Access Compliance Report

Public Rights-of-Way

Intersection ID: 7008	Main Street: MCALLISTER_DR	Cross Street: MERRILL_PL	Location: NE
ADA ID: 80633F327B13	Ramp Type: BlendTrans2	Initial Pass/Fail: Fail	Overall Compliance: No
		Severity Score: 25

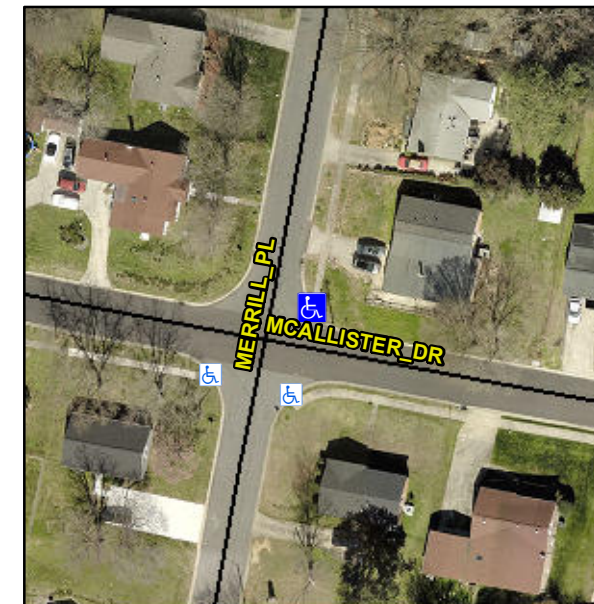
Not Found, R304.5.3

Compliance	Description	Data	Compliance	Description	Data
N/A	Ramp Length (in)	57.0	Yes	BlendTrans Slope (%)	4.2
Yes	Ramp Width (in)	62.0	No	BlendTrans XSlope (%)	8.1
N/A	Flare Type LT	N/A	N/A	Flare Type RT	N/A
N/A	Flare Slope LT (%)	N/A	N/A	Flare Slope RT (%)	N/A
N/A	Flare Traversable LT?	N/A	N/A	Flare Traversable RT?	N/A
N/A	Landing Length (in)	N/A	N/A	DWS Provided?	N/A
N/A	Landing Width (in)	N/A	N/A	DWS Contrast?	N/A
N/A	Landing Slope (%)	N/A	N/A	DWS Length (in)	N/A
N/A	Landing X Slope (%)	N/A	N/A	DWS Full Width?	N/A
N/A	Landing Curb? (Y/N)	N/A	N/A	DWS Offset (in)	N/A
N/A	Shared Landing?	N/A			
N/A	Gutter Ponding?	N/A	N/A	Gutter Slope (%)	N/A
N/A	Gutter Lip Ht (in)	1.0	N/A	Gutter X Slope (%)	N/A
N/A	Painted X Walk1?	No	N/A	Painted X Walk2?	N/A
	X Walk 1 Direction	To S		X Walk 2 Direction	N/A
	X Walk 1 Width (in)	N/A		X Walk 2 Width (in)	N/A
	X Walk 1 Slope (%)	1.6		X Walk 2 Slope (%)	N/A
	X Walk 1 X Slope (%)	6.6		X Walk 2 X Slope (%)	N/A

Remove & Replace Curb Ramp With Two New Directional Ramps or Equivalent.
